August 17, 2022

**RE: TDE Review – Traffic Analysis Review:
Crossgates Mall Rd and Gabriel Terrace/Dick’s Entrance**

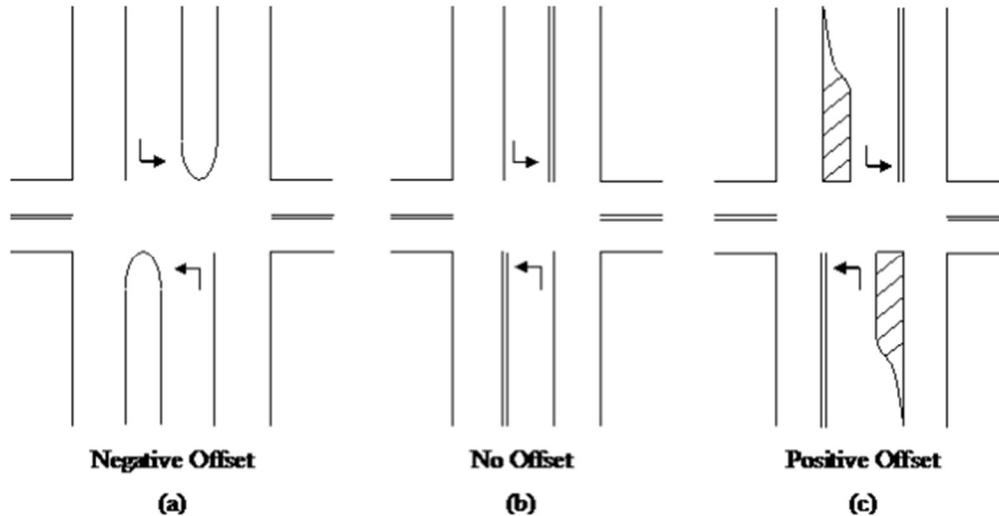
4. The analysis letter rejects the use of a mini-roundabout, suggesting that capacity would be an issue with such traffic control. However, even if a mini-roundabout wouldn't work, the analysis shows a single-lane roundabout has significantly more capacity than required. The Town would like to see concept sketches of a single-lane and double-lane roundabout with grading lines to better analyze if this option is feasible.
5. Left turn lanes along Crossgates Mall Rd at the intersection in the concept sketch show a striped median in a negative offset configuration. For increased safety, this should be striped with a positive offset. See figure below for an example of these configurations.
